**Regional Water Quality Control Board
North Coast Region
Second Pre-harvest Inspection Report**

From:	Art Haschak, RPF
From:	Dave Hope, RPF, CPESC
Subject:	Pre-Harvest Inspection Report for Timber Harvest Plan 1-00-101 MEN, Gualala Redwoods Inc. (landowner); North Fork Gualala River, Gualala River (watershed)

North Fork Gualala River showing “Clearcuts” narrow WLPZ and bedload issues.

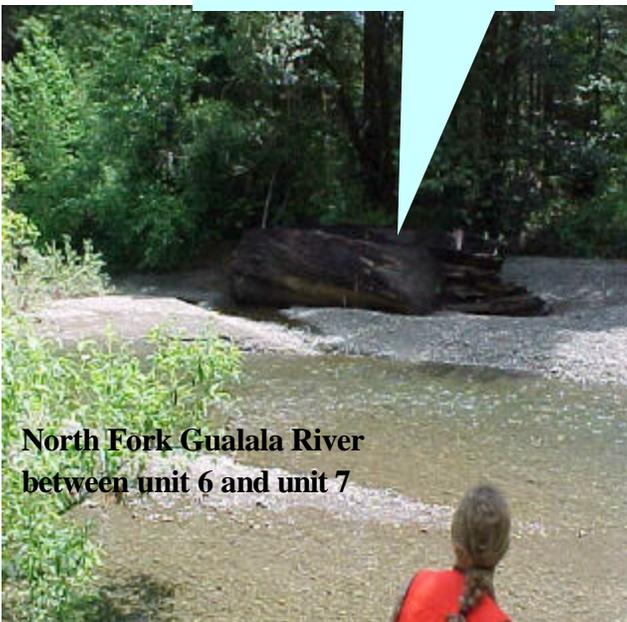
only WLPZ canopy is expected to ameliorate elevated stream temperatures, it needs to have very tall trees to shade the watercourse and a wide densely vegetated riparian corridor to reduce airflow and raise humidity. In this case the WLPZ canopy must be maximized to effectively moderate the impacts of nearby tracts of clearcuts and other timber harvest activity, additional WLPZ widths have been shown to increase protection

that is measurable out to 300 feet (Ledwith, 1996). The THP proposes to log an area within the floodplain of the Little North Fork Gualala, which has some of the best water temperatures that can be found in the planning watershed. This cold water refuge is not far below MWAT for coho salmon. Harvesting in this area could compromise this refugia habitat and further degrade the receiving waters downstream. Harvesting these areas is not appropriate due to the sensitivity of the area as a refuge for coho salmon, and the fact that the floodplains along this part of the Little North Fork are best classified as wetlands and are flooded by 1.5 to 2 years storm intervals.

**North Fork Gualala River
between unit 6 and unit 7**

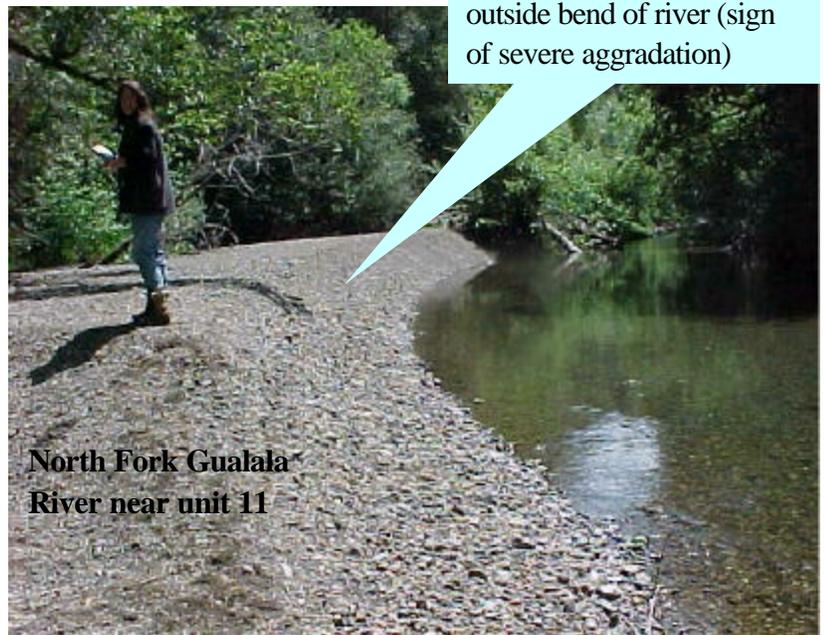
The North Fork of the Gualala River is heavily aggraded. The bedload in areas observed

LWD with a lot of work to do

**North Fork Gualala
River near unit 11**

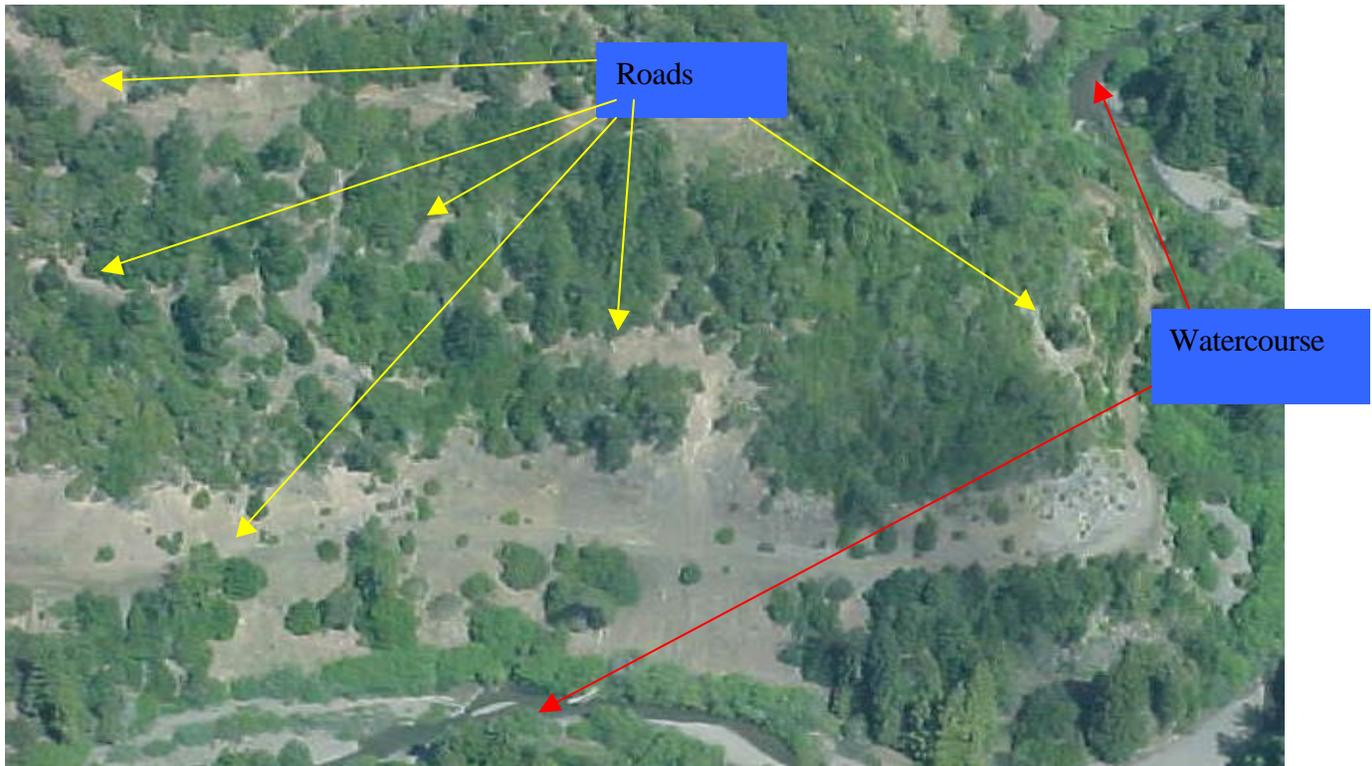
Gravel bar at aggraded outside bend of river (sign of severe aggradation)

in the North Fork Gualala River exceeds the transport capability of this river. This is evidenced by infilling of pools on the outside bend of the river.

Trees that were established and grew by the edge of the river for 20 to 30 years have recently died due to burying if the root systems by recent agradation. One of the most important issues facing this watershed is to reduce sediment delivery. In consort with this effort, the best short-term recovery element would be to significantly increase the instream and recruitable LWD and enlarge the WLPZ. An expanded WLPZ will increase sediment filtering

and storage capacity and provide refuge during floods for salmonids. Furthermore; with populations of coho salmon facing extinction, removal of any trees from an expanded WLPZ that can moderate the water temperatures, or provide much needed LWD habitat benefits, can not be justified **Recommendation 2.**
